From: Sandin Phillipson <sedphil24@comcast.net>
Sent: Thursday, August 15, 2019 1:44 PM
To: Tom Connelly
Cc: Wendy Scatterday
Subject: GC&P Development-Planning Commission Invited Comments
Attachments: Planning Commission Cover Letter.doc; Slope Stability of the Ridge.doc; Mine Subsidence.doc

After attending the August 12, 2019, meeting of the Planning Commission and reviewing the available material relevant to the proposal from GC&P Development, LLC (Applicant) regarding revision to Wheeling's Comprehensive Plan and consideration of zone change to facilitate their construction of a mixed use village adjacent to Woodsdale, I, as a resident of Woodsdale, have several concerns that I believe should be considered by the Commission. Given the state of the Applicant's submittal, I believe the current Comprehensive Plan designation for Parcel W26-90, W26-90.2, and W32-99.2 is appropriate and should not be changed. The Applicant's submittal package fails to address several important considerations, as described below.

Slope Stability of the Ridge
Bounded by
Woodsdale, Waddles Run, and SR88

Previous Mining and Mine Subsidence Potential

Figure 16. Cross section profile along the longitudinal axis of the ridge, with Woodsdale on left and Waddles Run on right, showing approximate extent of proposed excavation (white space) in relation to original profile (purple line).

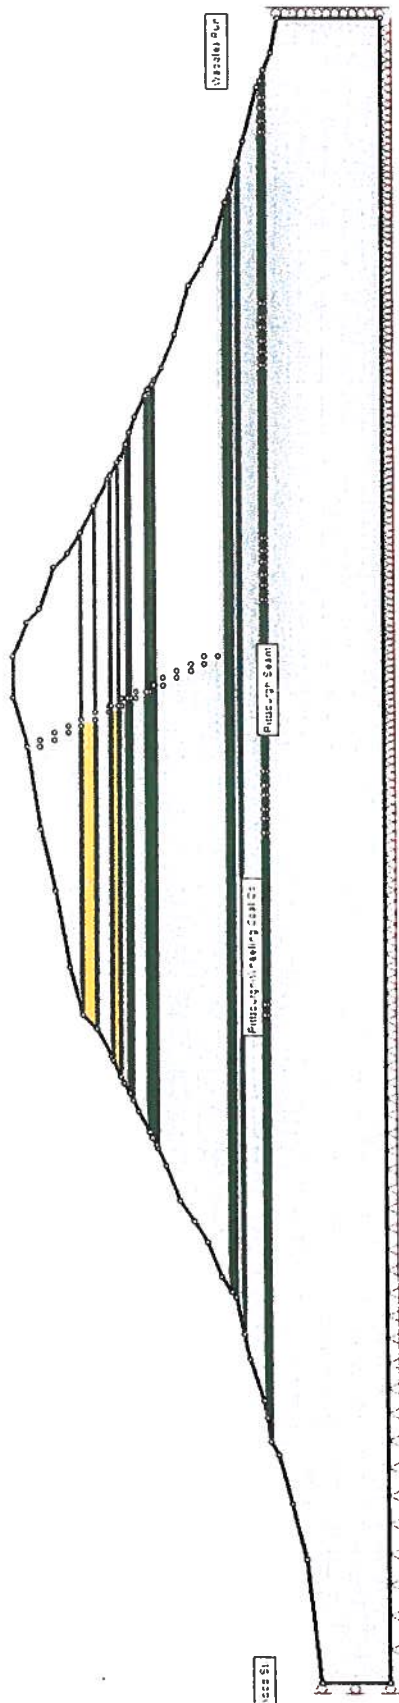
For further evaluation, Figure 16 represents the profile of the ridge bounded by Woodsdale on the south and Waddles Run on the north after proposed excavation to develop a flat pad to accept construction development. The original profile has been reduced by removal of the hilltop to the elevation of the property boundary of Parcel W26-90, from which point the final highwall steps down toward the north. Figure 17 presents the distribution of Strength Factor determined by finite element analysis for the remaining strata between the Pittsburgh Seam and the construction pad elevation. The prediction of failed elements in shear and tension, as well as Strength Factor values less than 1 (red and orange) is an indication that, if mine openings in the Wheeling Pittsburgh Coal Co.'s Edgwood Mine are still intact, subsidence into those openings can be considered likely. The distribution of red color, indicating potential for failure, indicates subsidence into panels previously described as having thin coal fenders, with tensile failures likely above the robust, intact pillars flanking former haulageways.
